## Design still water bending moments in CSR Bulk rules.

Ch.4 Sec.3 [2.2.1] and [2.2.2] and Ch.5 Sec.1 [4.2.1], [4.2.2], [4.2.4] and [4.3.1]

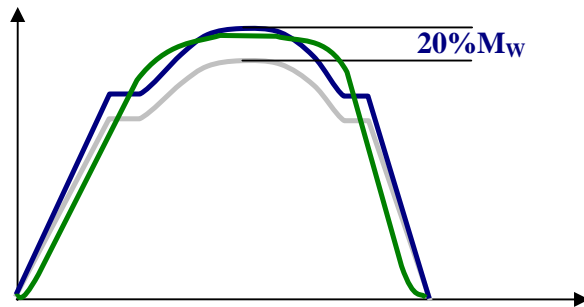
1(blue). Rule minimum Z (section modulus) is maintained within 0.4 L amidships according to Ch 5 Sec 1 [4.2.1] and [4.2.4]. Corresponding bending moments are given as preliminary design moments in Ch 4 Sec 3 [2.2.2].

2(green). Envelope curve for all loading conditions in the loading manual. For some points this may exceed the rule minimum requirement (ref. Ch.4 Sec.3 [2.2.1] and Ch.5 Sec.1 [4.2.2] and [4.3.1]).

3(red). Envelope (permissible) curve for loading manual/instrument.

Q1: As long as the item 1 is satisfied, i.e., Rule min. Z is maintained within 0.4L amidships, could “Alt 2” below be used as Envelope for the loading manual/instrument? Could “Alt 2” be used for sig-x for local scantlings and for design bending moment for FEM calculation? Note that the red line may have an uneven distribution within 0.4L amidships and might be below rule minimum (item 1 above).

Q2: In this connection, please clarify if Ch.4 Sec.3 [2.2.2] is a minimum requirement within 0.4L amidships or just a guidance. If it is not a rule minimum, and in case the Envelope (line 2) is below Min. Z (line 1), hull girder capacity of min Z is not fully utilised by the design/permissible still water bending moments of the vessel. As far as we understand, this is given as a minimum requirement for design still water bending moment in the CSR-Tanker rules. Please clarify.

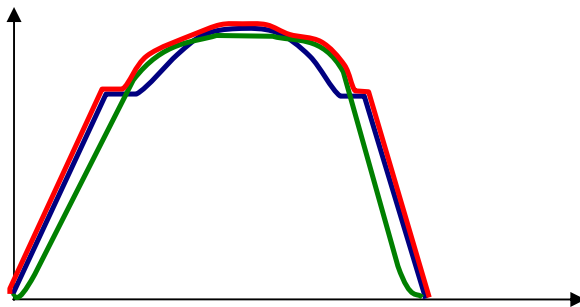
Q3: For the **flooding** condition, we assume the following relationship. We assume that the same principle also applies to harbour condition. Please confirm if our assumptions are correct.

1. Intact envelope
2. Intact envelope + 20% $M_{WV}$
3. Flooding envelope from flooding of design conditions

4. Envelope for loading manual/instrument

1. The intact bending moment based on above assumptions.
2. The Intact envelope + 20% $M_{VW}$
3. The envelope curves from flooding of design loading conditions. This curve exceed curve 2 for certain points.
4. Design limit for the flooding condition and envelope curve for loading manual/instrument.
